**BEAUFORT–PORT ROYAL
METROPOLITAN PLANNING COMMISSION
AGENDA**

- V. **Review of Projects for the City of Beaufort:**
 - A. **Watercrest – Multi-Family Development Sketch Plan and Street Names.** The applicant, Andrews Engineering, Inc. (Ryan Lyle), is requesting sketch plan and street name approval of a parcel located on the south side of Broad River Boulevard, approximately 250’ northeast of the intersection of WK Alston Drive and Broad River Boulevard Drive. The proposed development, currently referred to as Watercrest, will be a multi-family development that totals 37.7 acres.

WATERCREST

Staff Report for Metropolitan Planning Commission

MULTI-FAMILY CONCEPT PLAN 10

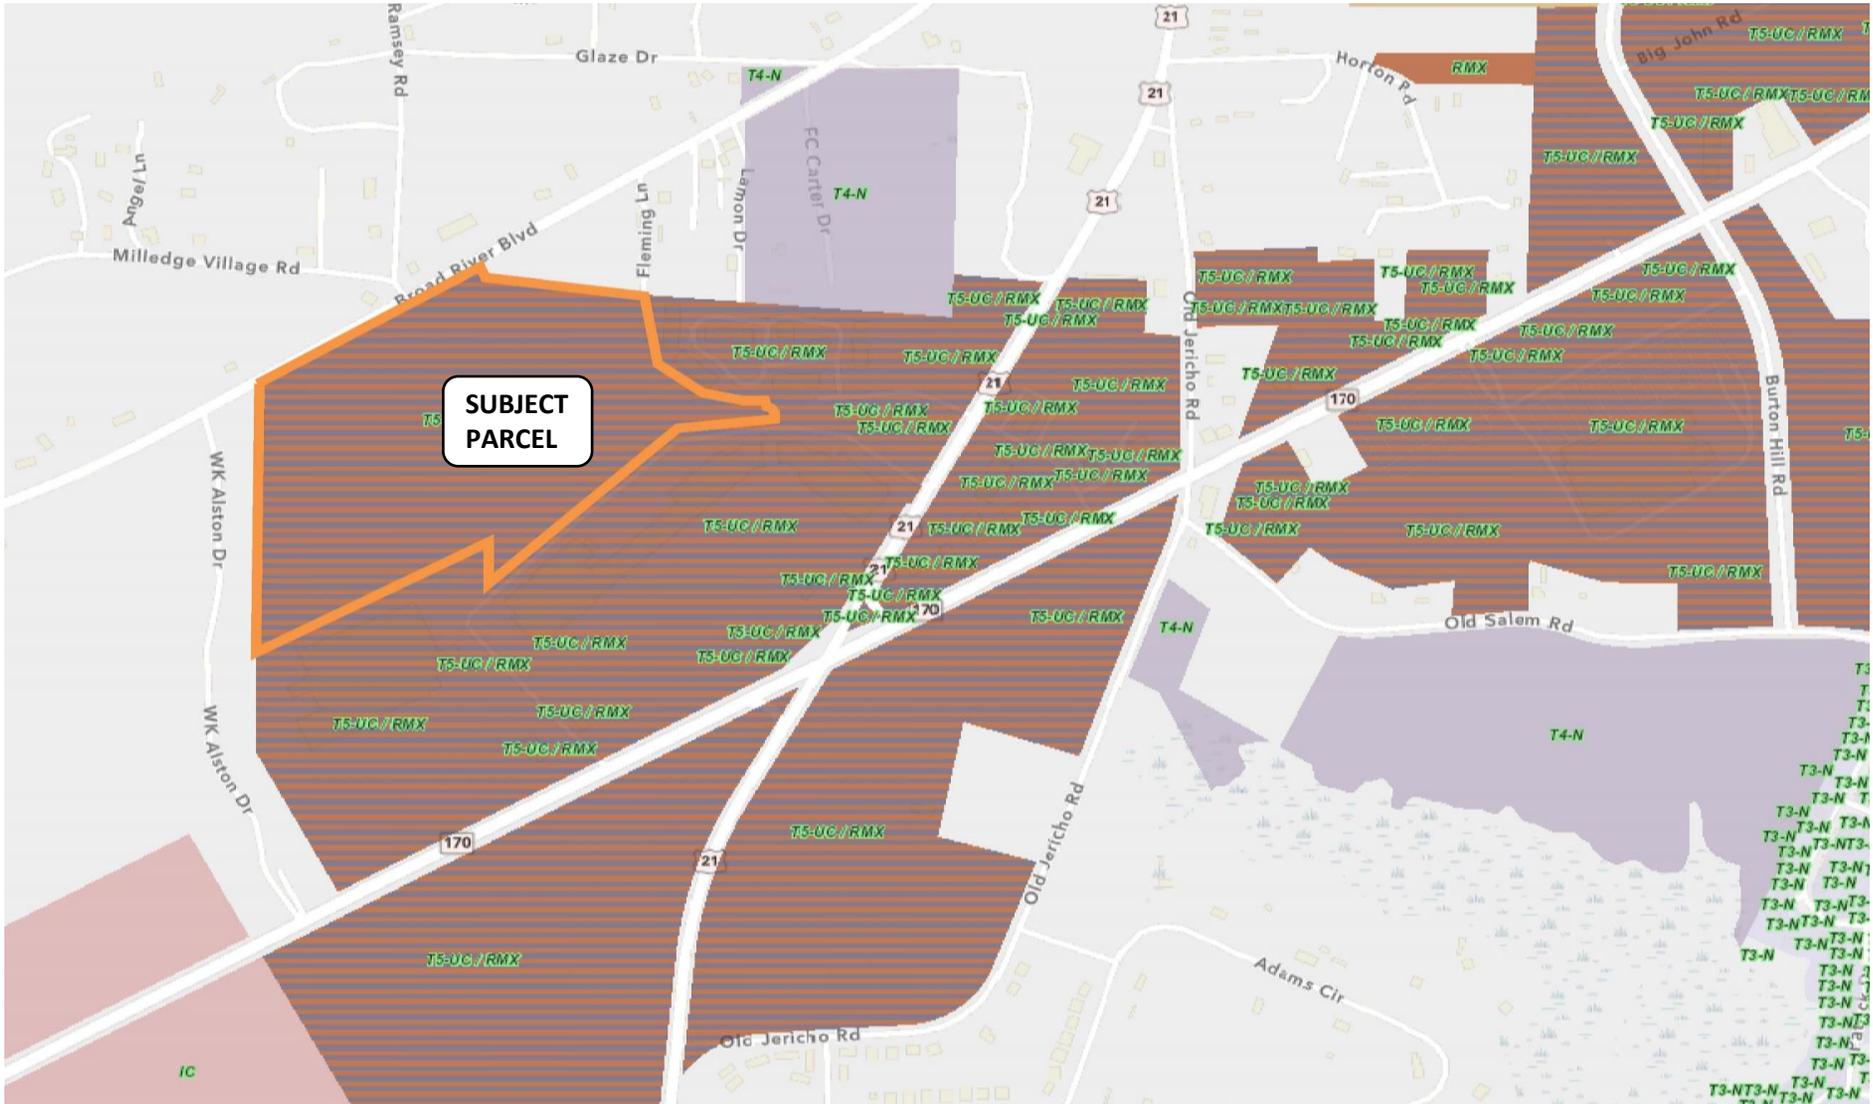
- D. Connectivity and Section 7.2 Street Network and Design Standards
All streets and street stubs shall meet the requirements of Section 7.2.2 Street Network Requirements. In accordance with Section 7.2.2, the Sketch Plan shows a development entrance on Broad River Boulevard, a stub to the west property line, and a tie to existing Ambrose Run at the east property line.

The Sketch Plan identifies the proposed street sections as Neighborhood Street 1-General (NS1). This meets the street section requirements of Beaufort Code Appendix C: Street Infrastructure Plans (Attachment C). However, the primary entrance off Broad River Boulevard is designed as a boulevard street section.

2. In future submissions, Applicant to show required setbacks per Section 2.4.1-2.4.2 on the proposed site plan. Setback lines appear to be shown, but the actual setbacks have not been labeled along the side and rear of the property, so there is no way for Staff to verify that the setbacks are shown correctly per T5-UC or RMX standards. It appears that the building locations are compliant with RMX standards, but Applicant to verify that this is correct. Although frontage requirements apply to

5. The proposed apartment buildings include a forecourt building frontage, but the provided dimensions do not demonstrate compliance with Section 4.4.B, which requires that a forecourt have a minimum depth of 12’ and a minimum width of 12’. See Staff Diagram for an illustration of Staff’s interpretation of how the requirements would apply to a building with a forecourt that involves a formal entry courtyard. Per Section 9.12.1.B, the administrator has the authority to authorize modification of up to 10% of any numerical standard set forth in Article 4. The administrator approves this 10% administrative adjustment to the dimensions set forth in Section 4.4.B, meaning that a 10.8’ deep and 10.8’ wide forecourt would be acceptable. Applicant to demonstrate compliance with these standards in future submissions and note that if the breezeway meets the minimum required width for a forecourt, a portion of the breezeway may be viewed as part of the required forecourt.
